**Florida Department of
Environmental Protection
Inspection Checklist**

Facility Name: VISTA LANDFILL, LLC (BUTTREY/KEENE RD SOUTH)
On-Site Inspection Start Date: 09/18/2017
On-Site Inspection End Date: 09/18/2017
WACS No.: 87081
Facility Street Address: 242 WEST KEENE RD
City: APOPKA
County Name: ORANGE
Zip: 32703

Construction Completion Certification Inspection for Landfill - Class III

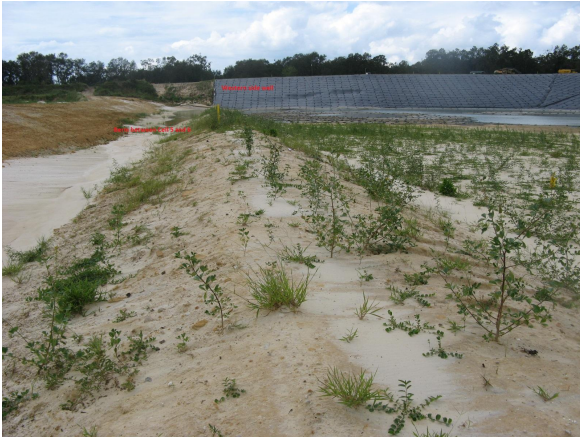
1. The cell entrance ramp and turn-around is located on the eastern side of the cell
2. Erosion in the southeastern side slope of Cell 5 from recent rain storm events was observed
3. Sand had also washed into the Cell bottom from recent storm.
4. Stormwater Pond 4 located to the west of the Cell had been excavated out.
5. The southern cell geosynthetic boundary was observed. The liner terminus was moved from its run-out location on the south side of the southern intercell berm up into an anchor trench on the top and in the middle of this berm.

The Cell Construction will be approved pending updating of Financial Assurance. Sheree Grant was reminded to submit a Permit modification which includes Financial Assurance update.
